**Russell Vale Colliery (formerly the NRE No. 1  
Mine) Underground Expansion Project**

**Groundwater Review**

Prepared for  
NSW Department of Planning and Infrastructure

Prepared by  
Coffey Geotechnics Pty Ltd  
Level 19, Tower B, 799 Pacific Highway  
Chatswood NSW 2067 Australia  
t: +61 2 9406 1026 f: +61 2 9406 1002  
ABN: 93 056 929 483

Figure 1. Interpreted hydraulic head distribution (broadly representative of early 2012) along a cross section through the area (after Coffey 2013a).

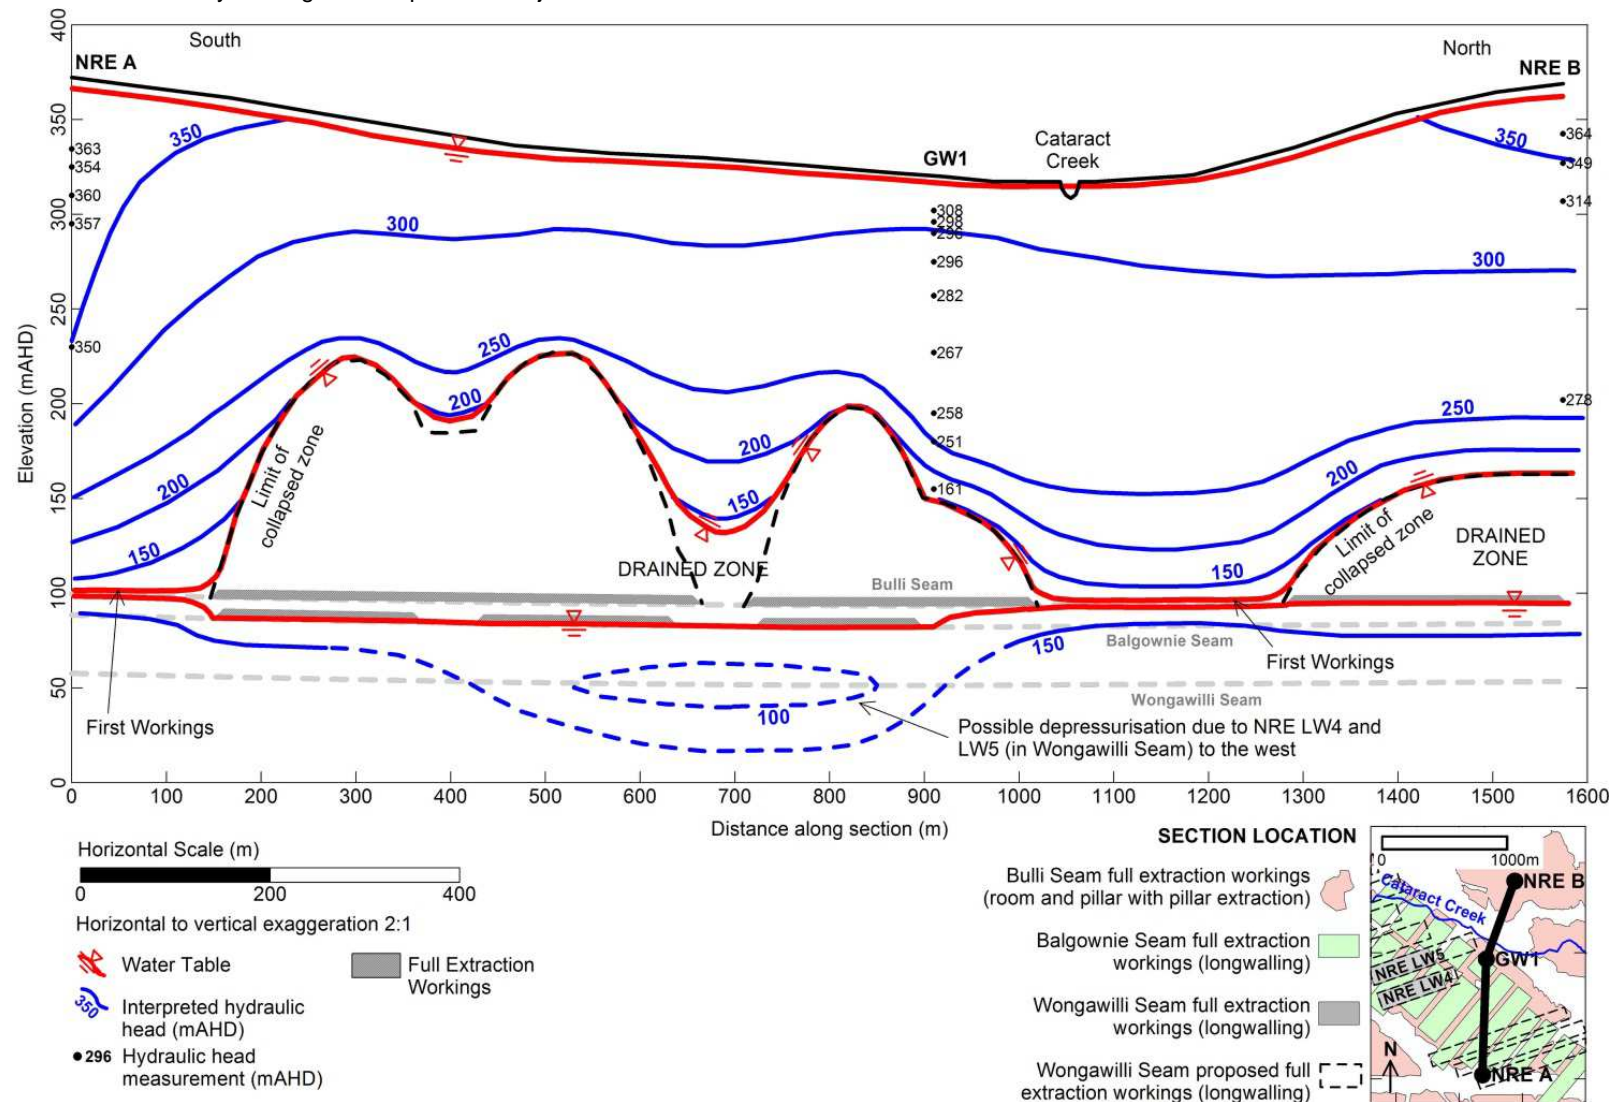
The Geoterra report (page 44) interprets that the pressure head profile at VWP site GW1 indicates a restriction to downward flow. Assuming a vertical 1-dimensional system (upon which the interpretation in the report appears to be based), a restriction would cause the basal pressure heads to increase, not decrease as is observed.

This interpretation requires an unsaturated zone between the sandstone and Bald Hill claystone, which is not supported by data. However, this assumption may not impact the project since in the numerical simulation all model layers communicate hydraulically with adjacent layers via the vertical hydraulic conductivity parameter (or its unsaturated function).

**Figure A2. Pressure head versus height above the mined seam for fractured rock media at Mandalong Mine.**

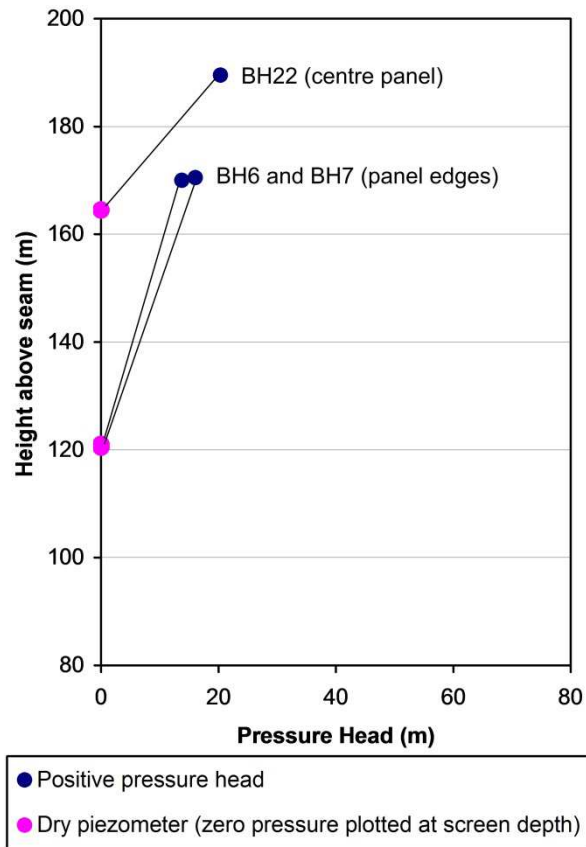
Figure A2 shows the data from Table A1 plotted as pressure head versus height above the seam. Dry piezometers are plotted as zero pressure at the location of the screen. Given the mass of data available from other piezometers, and the severe gradient in water level fall at BH6B and BH22 when undermined, saturation below dry piezometers is considered highly unlikely. BH18 also overlies a panel, however it went dry with  $dh/dt$  typical of a far field sink, and is not incorporated into these calculations.

From Figure A2, the height above the seam at which pressure head becomes zero is as follows:

- BH6 nest: Between 121m and 170m (average of 146m)
- BH7 nest: Between 121m and 171m (average of 146m)
- BH22 nest: Between 165m and 190m (average of 178m)

The height of desaturation at BH6 and BH7 became fully developed immediately after undermining. However, at BH22 (centre panel),  $H$  became fully developed about 1 year after undermining, probably related to the time required for the stress field to fully redistribute itself.

**Figure A3. Results from water level monitoring in fractured rock media at the Mandalong Mine, for piezometer nests BH6, BH7, and BH22. The height where the pressure head becomes zero is estimated as the midpoint between the last saturated and first dry piezometer moving down the profile.**

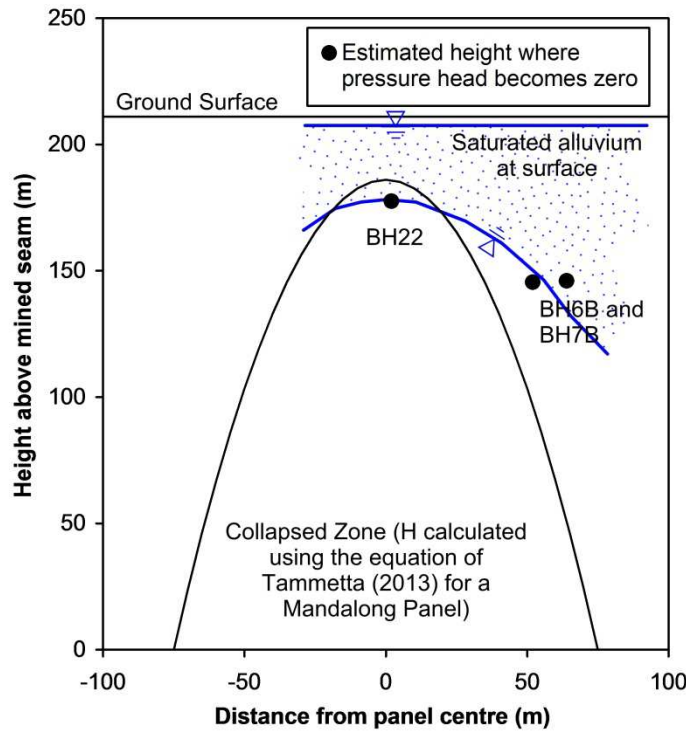
The average observed  $H$  at BH22 is 178m. The equation of Tammetta (2013) predicts an  $H$  of about 190m. These results accord well with the results of Tammetta (2013), and constitute a good example of demonstrating the base of saturation over centre panel, and also in moving away from centre panel. Tammetta (2013) incorporated monitoring data from BH22 in that study, interpreting an  $H$  of 175m. Figure A3 shows the estimated boundary of the collapsed zone specifically for a Mandalong panel, with an average overburden thickness of 211m (the average for BH6, BH7, and BH22), and the estimated heights at which pressure head becomes zero.

**Figure A4. Comparison of heights of desaturation at Mandalong and Springvale Mines, using normalised heights above the seam and normalised distances from centre panel, to allow comparison.**

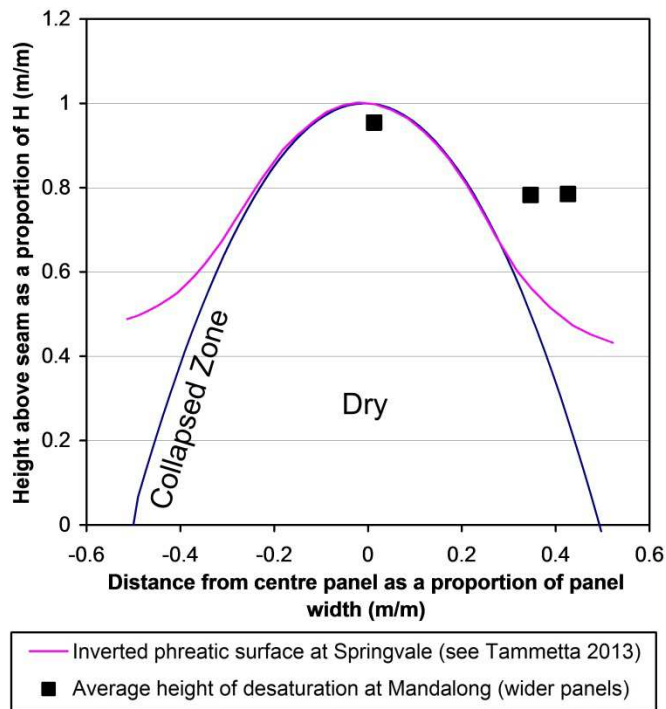
Figure A4 shows the data from Figure A3 plotted with the results from Springvale Colliery (see Tammetta 2014). The data are normalised to allow comparison (that is, the height above the seam is divided by  $H$  and the distance from centre panel is divided by  $w$ ). The location of the inverted phreatic surface, and its proportional extension down the chain pillar, is in accord with results from Springvale Colliery (see Tammetta 2013). The height of desaturation above pillars from Springvale is actually smaller than for Mandalong, indicating that at Mandalong, caving causes higher desaturation at panel edges. The Mandalong data therefore provide a good example of accord with the equation of Tammetta (2013), and observed  $H$  at other mines, especially Springvale Colliery.

**Figure A5. Locations of piezometer nests and longwall panels, and boundary of the Wyong soil. The figure base is from Figure 2 of Centennial Coal (2010).**

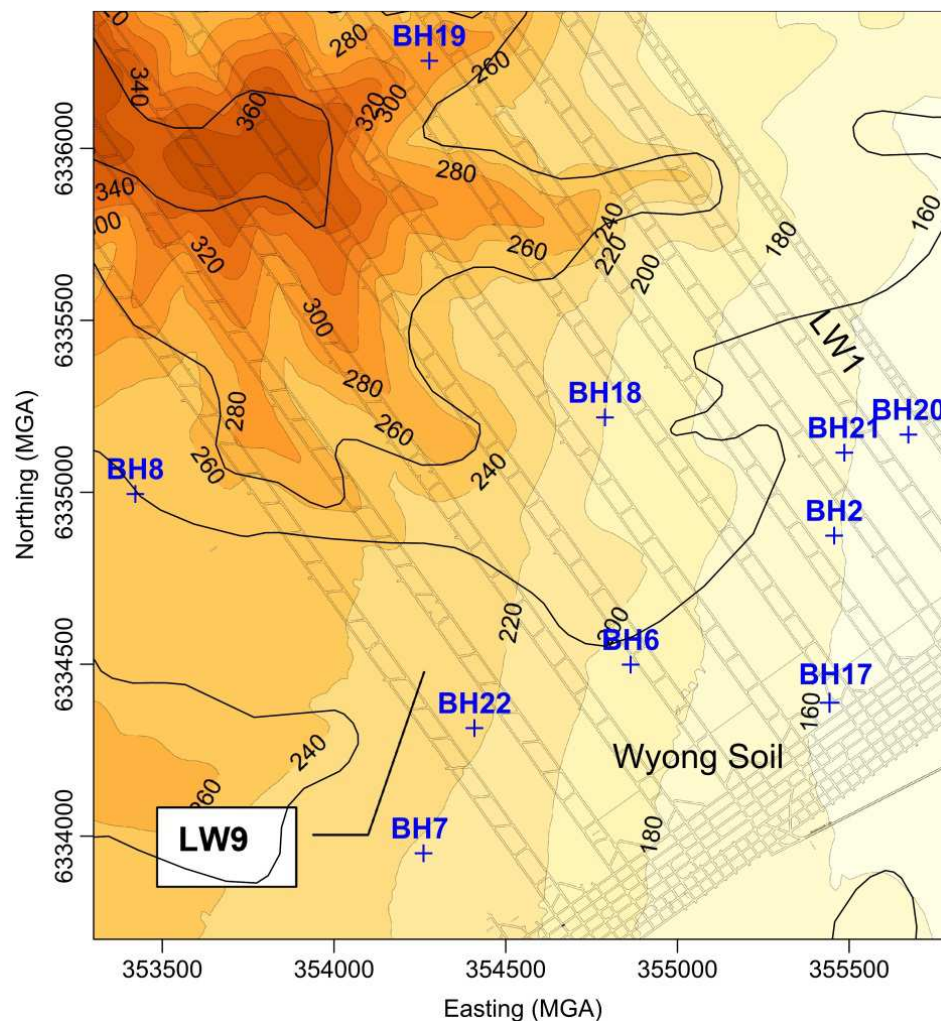
A localised cluster of piezometer nests further northeast (BH2, BH20, and BH21, see Figure A5) have also been undermined but appear to show maintenance of saturation. These piezometers are located over panels LW1 to LW3, which are thinner (void width of approximately 120m from AGE 2012) than panels underlying the piezometers analysed above. These piezometers are located down topographic gradient where the surface alluvium may be thicker (alluvial thickness measurements were unavailable) and may constitute the presence of a potential high conductivity saturated body at the surface, which could reduce  $H$ . Figure A5 shows the piezometer nest locations. The average  $H$  calculated from Tammetta (2013) is approximately 145m at these locations.

Records in AGE (2012) indicate the presence of a fault that was intersected at LW1 (see Figure A5) in mid-2005 and which appears to have markedly accentuated the drawdown at BH17. The statement that intersection was at the outbye side of the panel, and taking into account the impact vector to BH17, suggests the fault forms a small angle with the panel (and possibly runs nearly north-south, parallel with a water course about 500m to the east) and would therefore be of little influence at the locations of BH6, BH7, and BH12 further west.

**Figure A6. Pressure heads versus height above the mined seam for BH2, BH20, and BH21.**

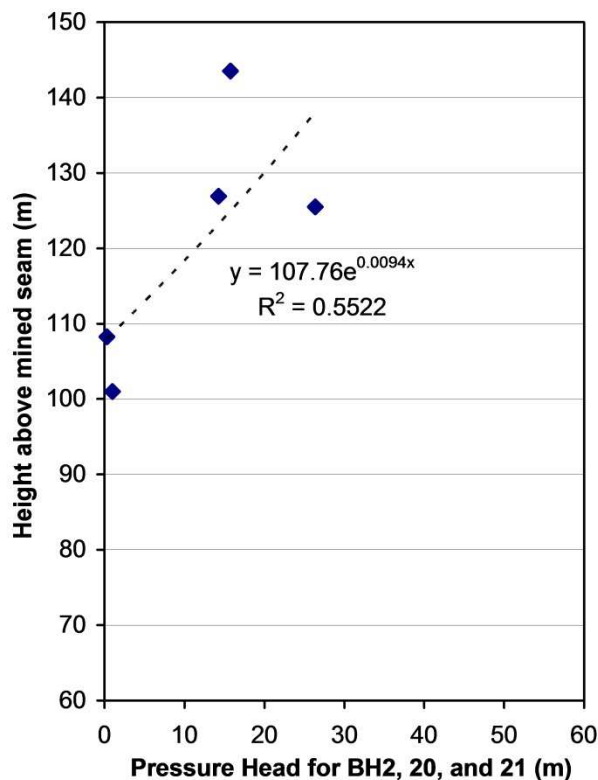
The fault may accentuate the role played by the alluvium (with potentially high  $K$ ) in reducing  $H$  at the locations of BH2, BH20, and BH21, by increasing the vertical downward flux from the alluvial body to the fractured rock media, thereby reducing  $H$ . Figure A6 shows the pressure heads for BH2, BH20, and BH21, versus mined height. Observations indicate  $H$  of between about 100m and 110m above the mined seam. This is about 40m lower than the calculated  $H$ . This accords strongly with other locations where in Tammetta (2013) where the panel underlies a flowing river or saturated high permeability alluvium. The other locations indicate a height of desaturation which is consistently 40m to 50m smaller than for the ordinary case (see Tammetta 2013). The Mandalong data demonstrate another example of this situation.

**Figure A7. Pressure head versus height above the mined seam for fractured rock media at Mandalong Mine.**

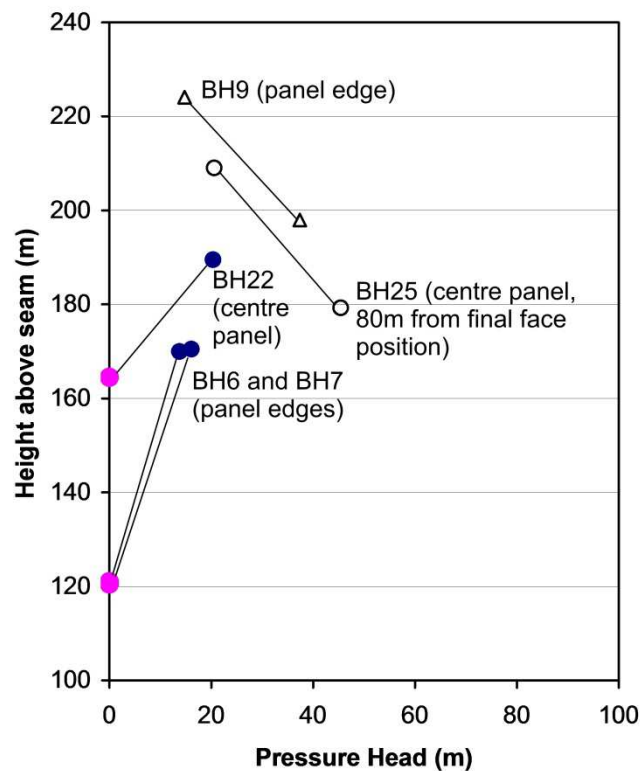
Figure A7 shows the data from Table A2 plotted as pressure head versus height above the seam, compared to pressure heads for VH6, BH7, and BH22.

The average H calculated from Tammetta (2013) is approximately 190m at these locations. The following salient features are interpreted:

- The lower screen at BH9 is probably too high in the profile to show desaturation (the height of desaturation at BH9 will be markedly smaller than calculated  $H$ ).

- Given the location of the BH25 nest, water levels at BH25 will behave as if it were near the side of a panel. This is because of the attenuation of deformation due to end effects. Thus, the height of desaturation at BH25 will be markedly smaller than calculated  $H$ . As a result, the lower screen at BH25 is likely to be too high in the profile to show desaturation either now or in the future. The reason for the behaviour at BH25 is due to the pattern of goaf compaction, which is an indicator of overburden deformation. The distribution of goaf compaction is as shown in Figure A8 (data from Wachell 2012). This pattern accords with field observations from drilling investigations (Zhang and Shen 2004, Xu et al. 2010, Bai and Elsworth 1989, and Zhang et al. 2011) where the shape of the goaf zone is interpreted as being squat in cross-section with vertically extended lobes near the panel edges. At the final face position, deformation is thought to be much reduced compared to centre panel further back along the long dimension of the panel.
